**SOLICITATION AMENDMENT
MODIFICATION DE L'INVITATION**

Title - Sujet Bay 3 Refit	
Solicitation No. - N° de l'invitation 9F023-200546/A	Amendment No. - N° modif. 011
Client Reference No. - N° de référence du client 20200546	Date 2022-01-13
GETS Reference No. - N° de référence de SEAG PW-\$\$\$FG-380-80685	
File No. - N° de dossier fg380.9F023-200546	CCC No./N° CCC - FMS No./N° VME
Solicitation Closes - L'invitation prend fin at - à 02:00 PM Eastern Standard Time EST on - le 2022-01-21 Heure Normale du l'Est HNE	
F.O.B. - F.A.B. Plant-Usine: <input type="checkbox"/> Destination: <input type="checkbox"/> Other-Autre: <input type="checkbox"/>	
Address Enquiries to: - Adresser toutes questions à: Turner, Jason	Buyer Id - Id de l'acheteur fg380
Telephone No. - N° de téléphone (343) 574-2818 ()	FAX No. - N° de FAX () -
Destination - of Goods, Services, and Construction: Destination - des biens, services et construction:

The Amendment No.011 is issued for the following reason:

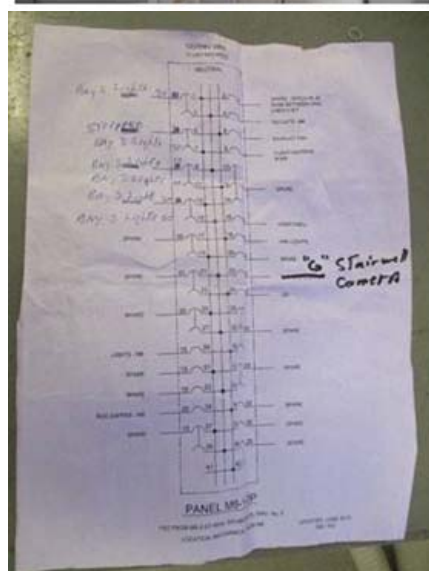
Question 38: Please provide a photo of the existing M6-DP1 and SP1, showing the make, model and existing breaker type.

Answer 38: SP1 pictures provided in amendment 007, DP1 pictures below
